Access Compliance Report

Public Rights-of-Way

(Curb Ramps)

Intersection ID: 30125	Main Street: CLOONEY_LN	Cross Street: RUMPLE_RD	Location: NW
ADA ID: 1EDDEF83F388	Ramp Type: Perp	Initial Pass/Fail: Pass	Overall Compliance: No
Severity Score: 22.5			
Codes/Mitigation Info/Possible Solution		Field Measurements/Component Compliance

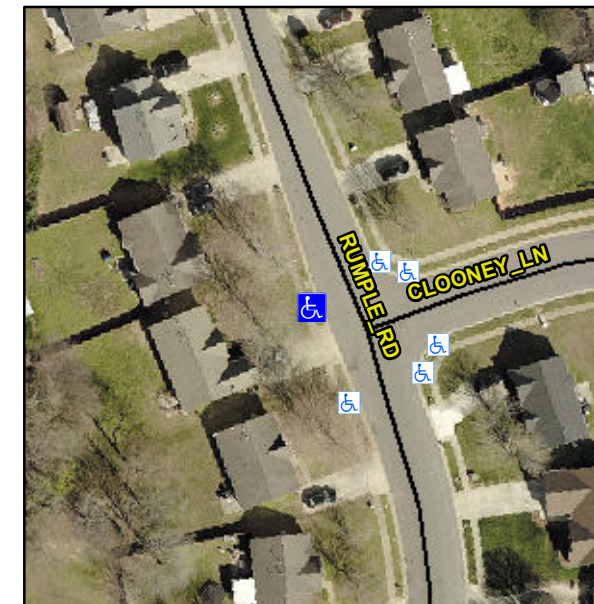
**Not Found, R304.2.1, R304.5.3,
R305.1.4, R302.7.2, R304.5.4**

Compliance	Description	Data	Compliance	Description	Data
N/A	Ramp Length (in)	50.0	Yes	Ramp Slope (%)	7.2
Yes	Ramp Width (in)	51.5	Yes	Ramp XSlope (%)	1.1
N/A	Flare Type LT	Sloped	N/A	Flare Type RT	N/A
N/A	Flare Slope LT (%)	5.9	N/A	Flare Slope RT (%)	14.1
N/A	Flare Traversable LT?	No	N/A	Flare Traversable RT?	No
No	Landing Length (in)	47.0	Yes	DWS Provided?	Yes
Yes	Landing Width (in)	51.5	Yes	DWS Contrast?	Yes
Yes	Landing Slope (%)	1.2	Yes	DWS Length (in)	25.5
No	Landing X Slope (%)	4.0	No	DWS Full Width?	No
N/A	Landing Curb? (Y/N)	No	Yes	DWS Offset (in)	2.0
N/A	Shared Landing?	No			
Yes	Gutter Ponding?	No	No	Gutter Slope (%)	11.0
No	Gutter Lip Ht (in)	1.0	No	Gutter X Slope (%)	2.7
N/A	Painted X Walk1?	No	N/A	Painted X Walk2?	N/A
	X Walk 1 Direction	To E		X Walk 2 Direction	N/A
N/A	X Walk 1 Width (in)	N/A	N/A	X Walk 2 Width (in)	N/A
	X Walk 1 Slope (%)	8.8		X Walk 2 Slope (%)	N/A
	X Walk 1 X Slope (%)	1.9		X Walk 2 X Slope (%)	N/A

N/A	Ramp inside XWalk1?	N/A	N/A	Ramp inside XWalk2?	N/A
	Road Slope (%)	N/A	N/A	Clear Space?	Yes
	Road X Slope (%)	N/A	N/A	Clear Space to XWalk (in)	N/A
Yes	Any Obstructions?	No	Yes	Storm Grate/Utility Hazard?	No
	Obstruction Type			Storm Grate/Utility Type	
		N/A			N/A
			Yes	Surface Condition? (G/P)	Good

**Remove & Replace Entire Ramp.
Remove & Replace Gutter.**
